<b>TAL-CO SUPPLEMENTAL INSTRUCTION #70 REV 01</b>			
<b>CAFETERIA - REVISED CLOSER PANEL DETAIL</b>			
Project Name:	<b>RW TOMLINSON - NEW HEAD OFFICE</b>		
Project Location:	<b>100 CitiGate Drive, Ottawa, Ontario</b>		
ARCH. SI #:	<b>ASK 206 REV 01</b>	Issued By:	<b>Farah Bano</b>
STRUC. SI #:	<b>N/A</b>	Date Issued:	<b>November 9, 2017</b>
MECH. SI #:	<b>N/A</b>	Revision #:	<b>01</b>
ELEC. SI #:	<b>N/A</b>	Revision Date:	<b>November 13, 2017</b>

**TITLE: CAFETERIA - REVISED CLOSER PANEL DETAIL**

PROJECT:  
 TOMLINSON NEW BUILDING

**ASK-206**

**22** ROOM 114 SOUTH ELEVATION  
 A771 SCALE = 1:50

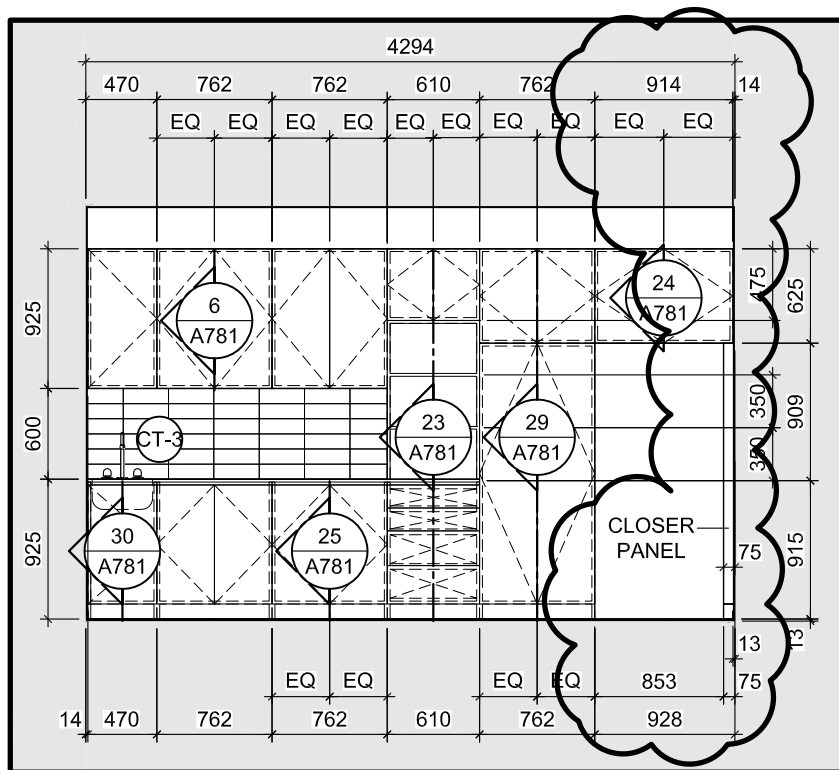
Closer Panel detail at Ground Floor Cafeteria Millwork piece M20 revised.

The ice maker issued in the previous instruction has now been cancelled as per owner's request.

Closer Panel detail revised to accommodate refrigerator.
